Pinnacle at Liberty Bay Development — Public Notice and Unresolved Review Issues

Re: Pinnacle at Liberty Bay PRD - Protected Avian Species and Habitat Review

Subject: PUBLIC COMMENT: Roadway Geometry & Safety Deficiencies – Pinnacle at Liberty Bay (Permit No. P-06-20-25-03)

Re: Pinnacle and Liberty Bay PRD Second Public Comment Period

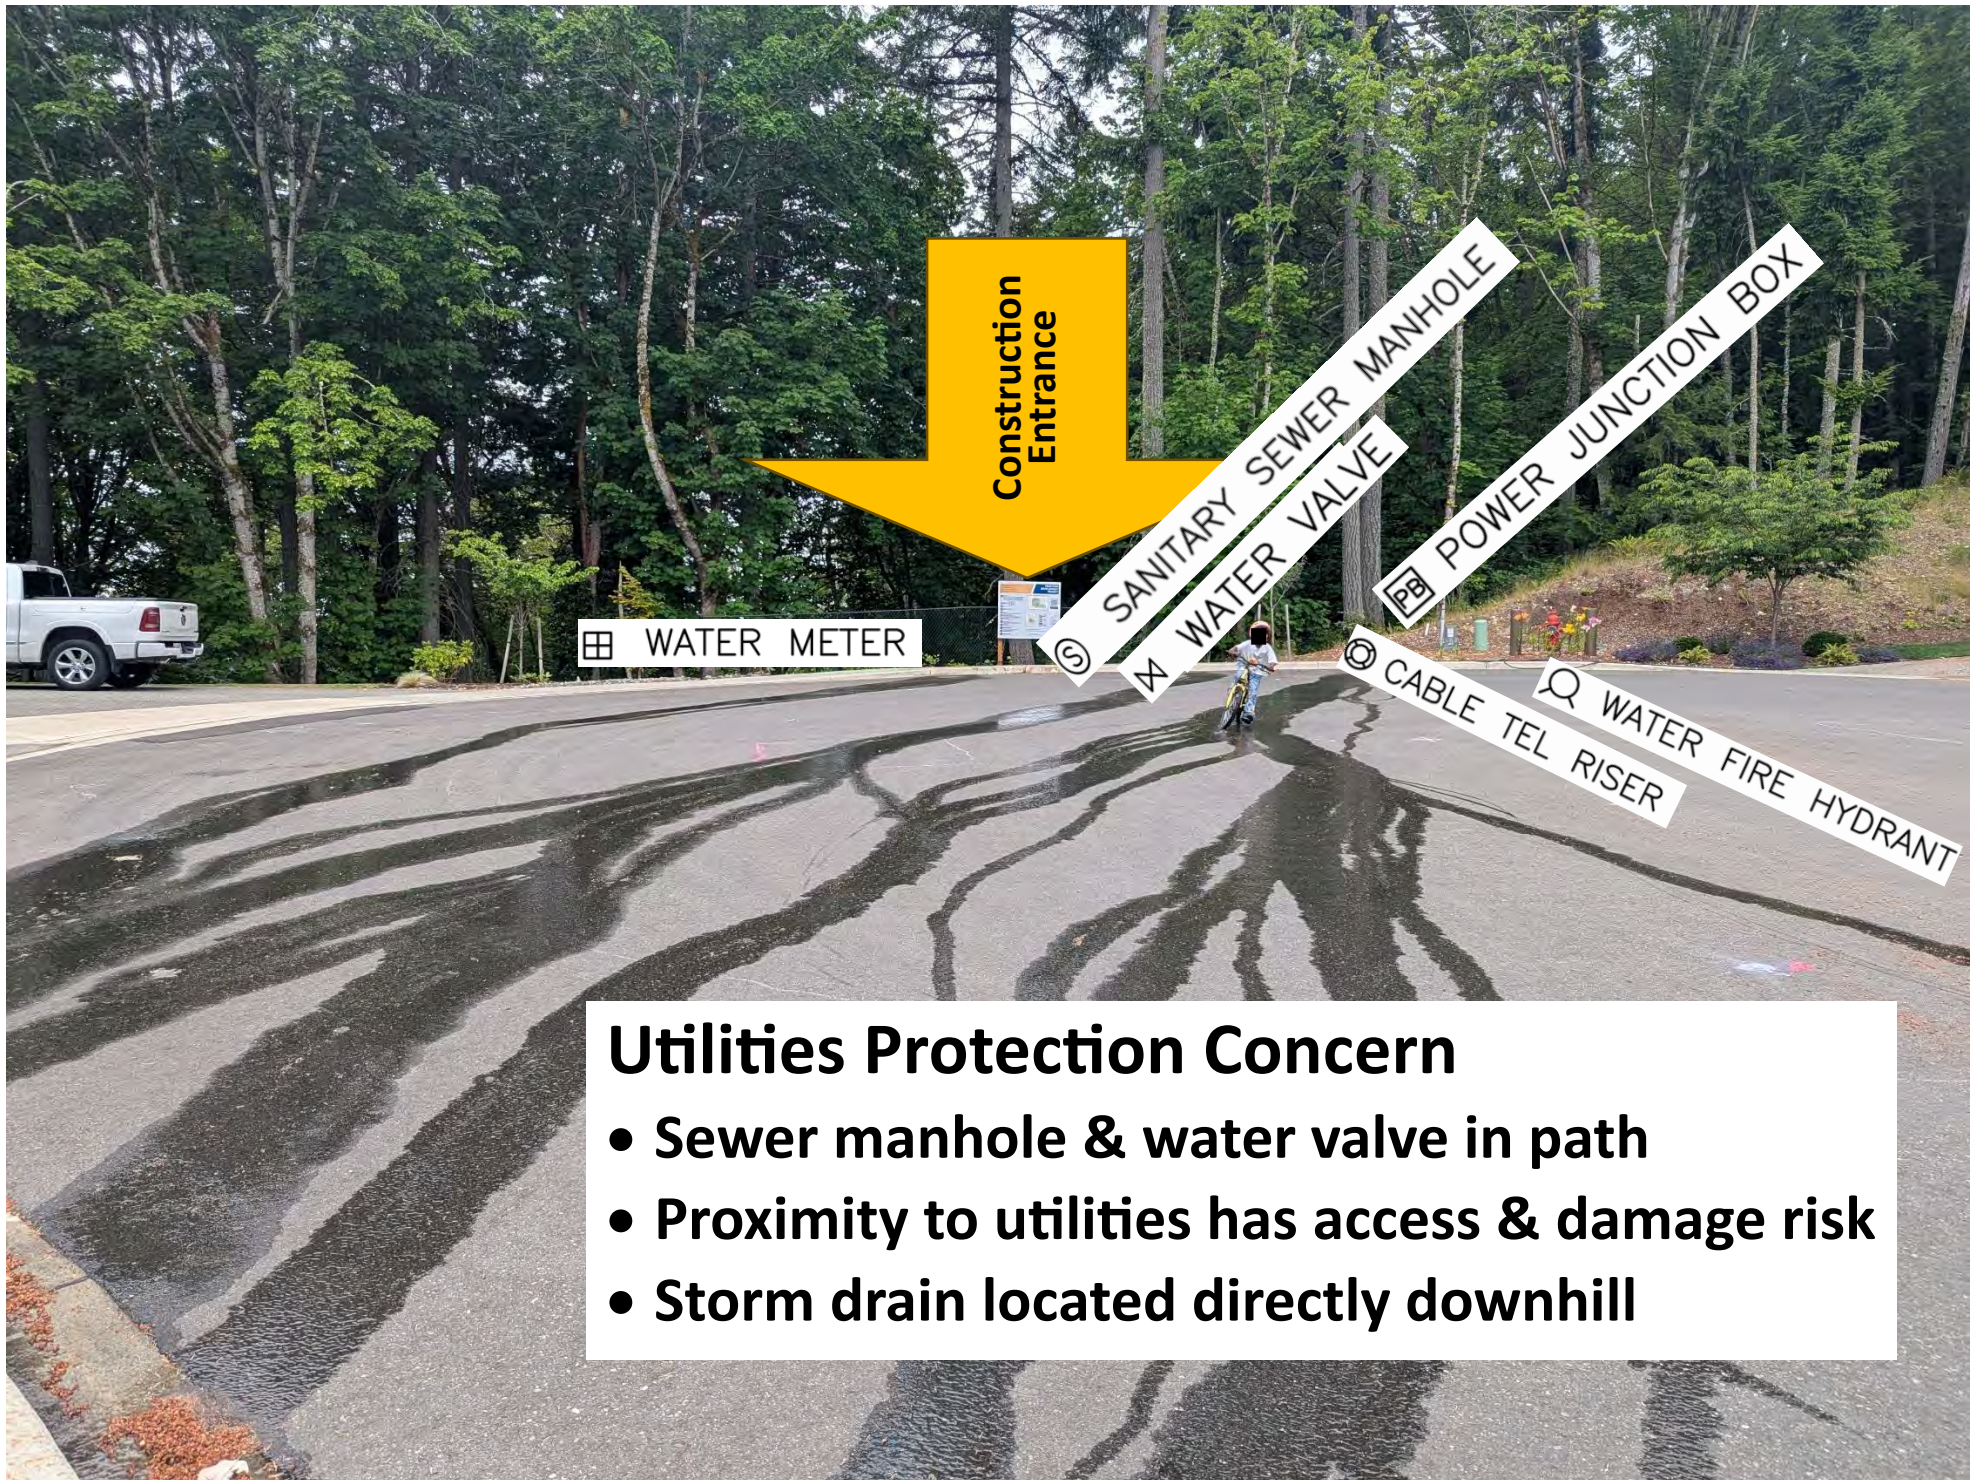
Pedestrian Safety Concerns:

- **Crystallia Ct is highly utilized by children**
- **Poor visibility – crest of construction entrance**
- **Removal of safety fence overlapping entrance**

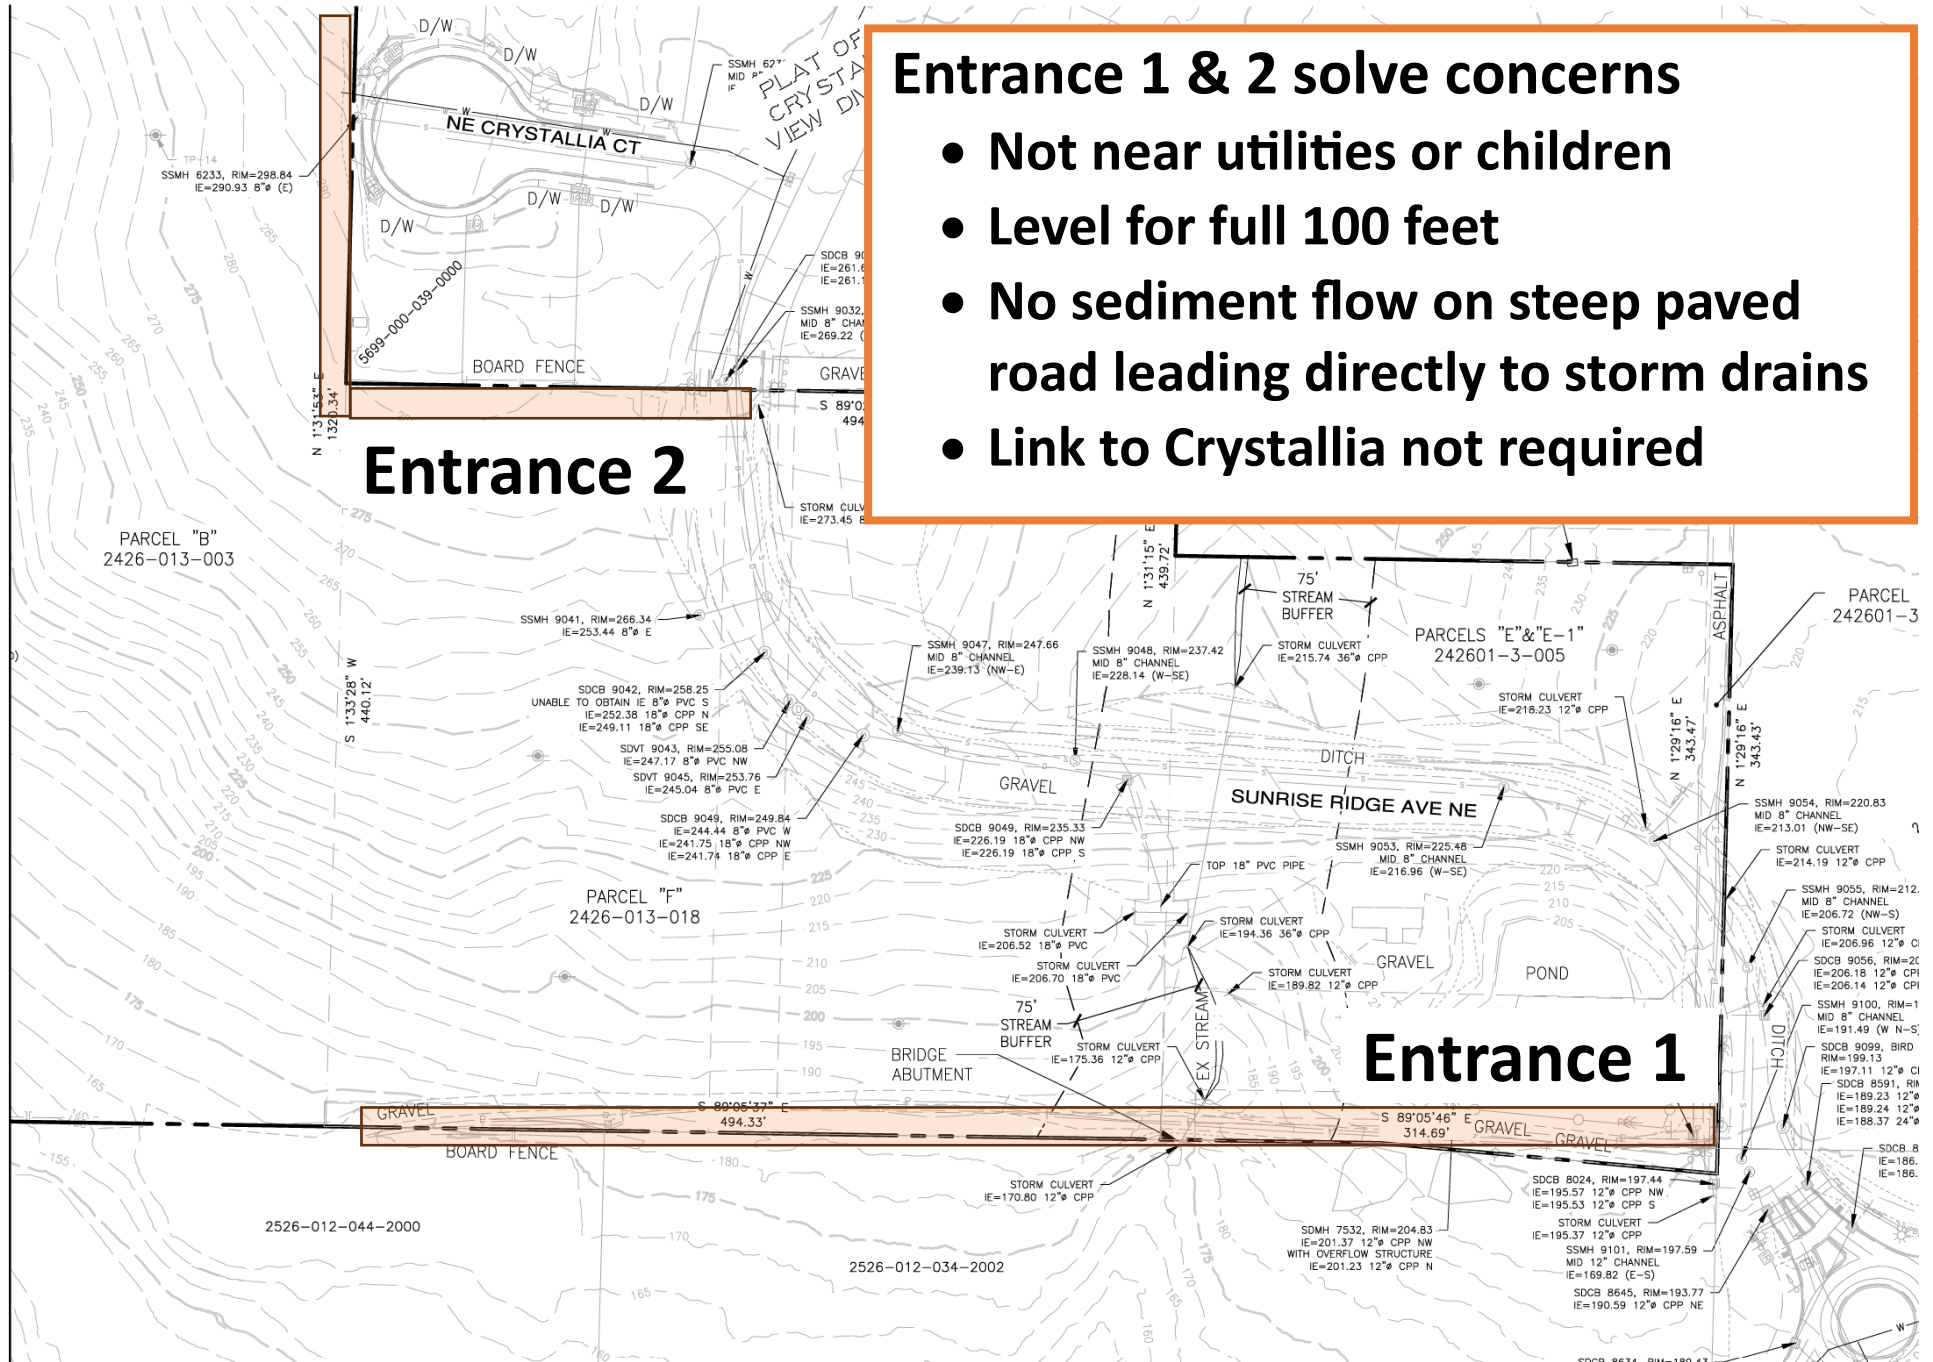
Manhole + 12 ft: 5 ft. drop = 42% grade

Manhole + 80 feet 12 ft drop = 15% grade

Manhole + 100 feet 25 ft drop = 25% grade

Entrance 1 & 2 solve concerns
